**ADDENDUM #2**

ISSUE DATE: **June 12, 2024**

RE: **GOLDA MEIR LIBRARY LUBAR CONFERENCE RENOVATION  
UNIVERSITY OF WISCONSIN – MILWAUKEE  
GPC (GENERAL PRIME CONTRACTORS) BID DOCUMENTS  
UWSA Project No. B-23-001**

**E103**

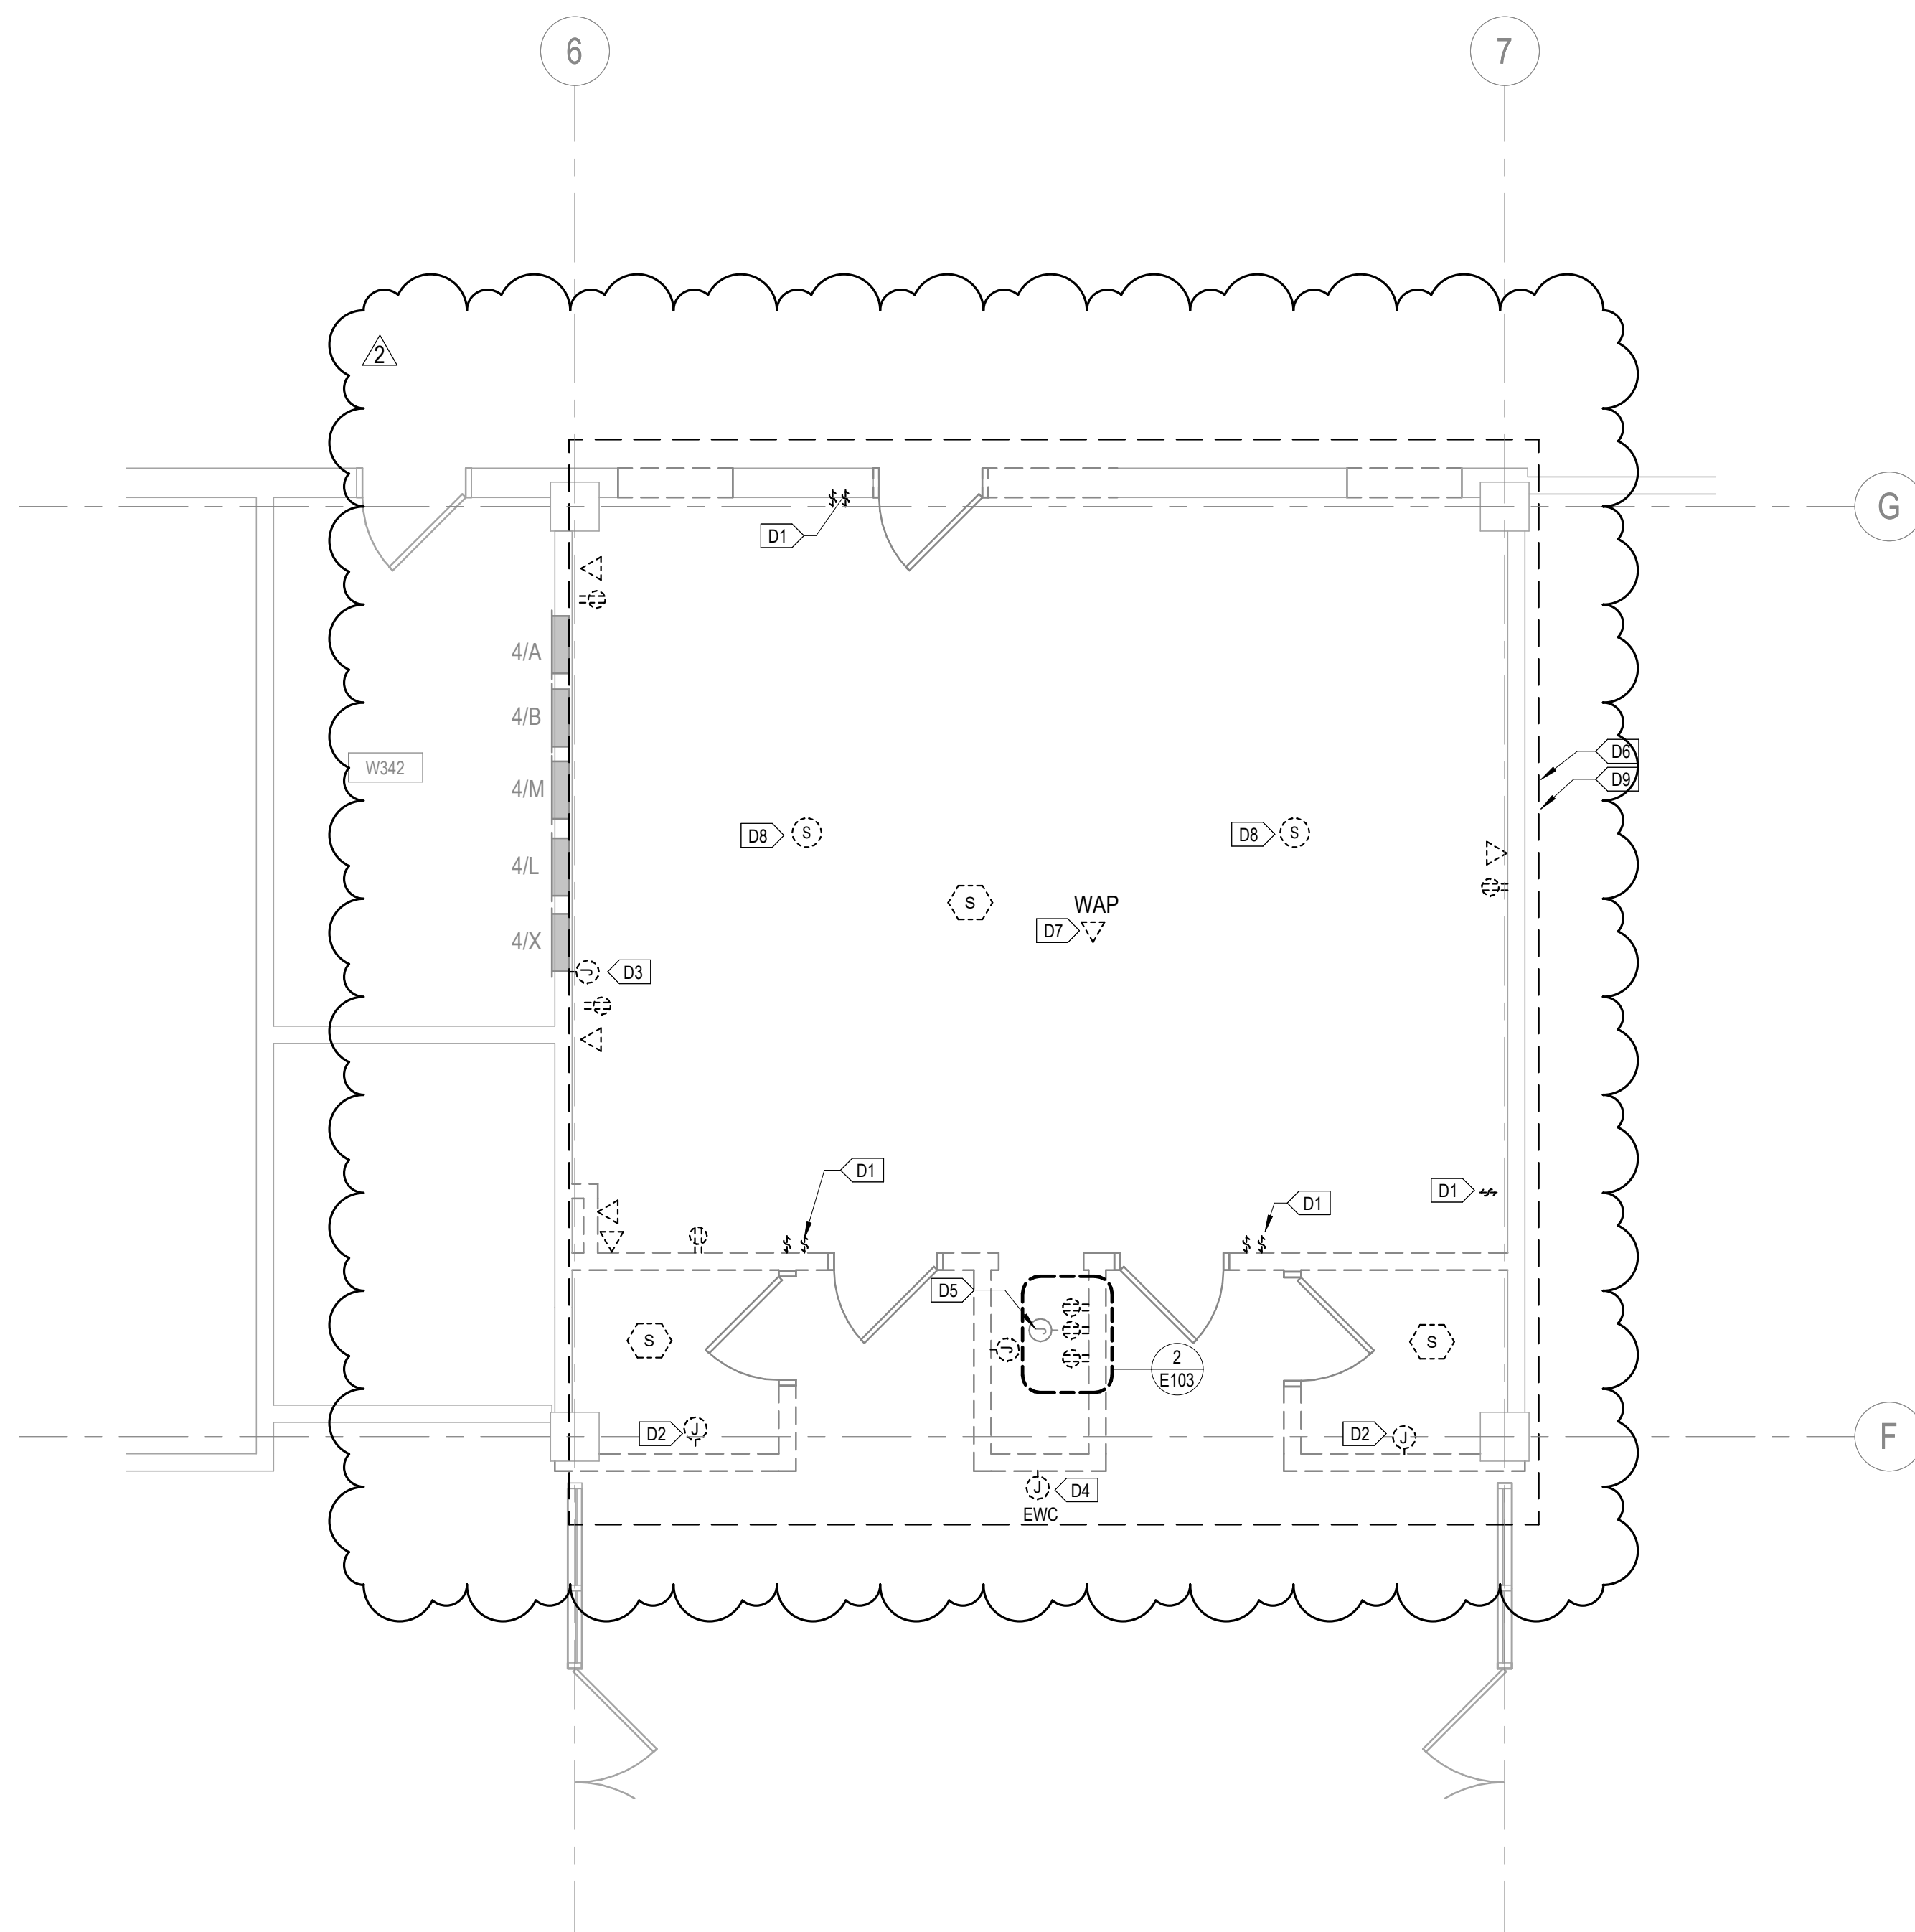
- E103
  - Architectural backgrounds did not properly print in the previously released set. Updated drawings to show backgrounds.
- E203
  - Architectural backgrounds did not properly print in the previously released set. Updated drawings to show backgrounds.
- E303
  - Removed 2D data device mounted at 18” on the plan west wall.
- E601
  - Updated detail #5 to reflect the removal of the 18” mounted 2D data device on E303.
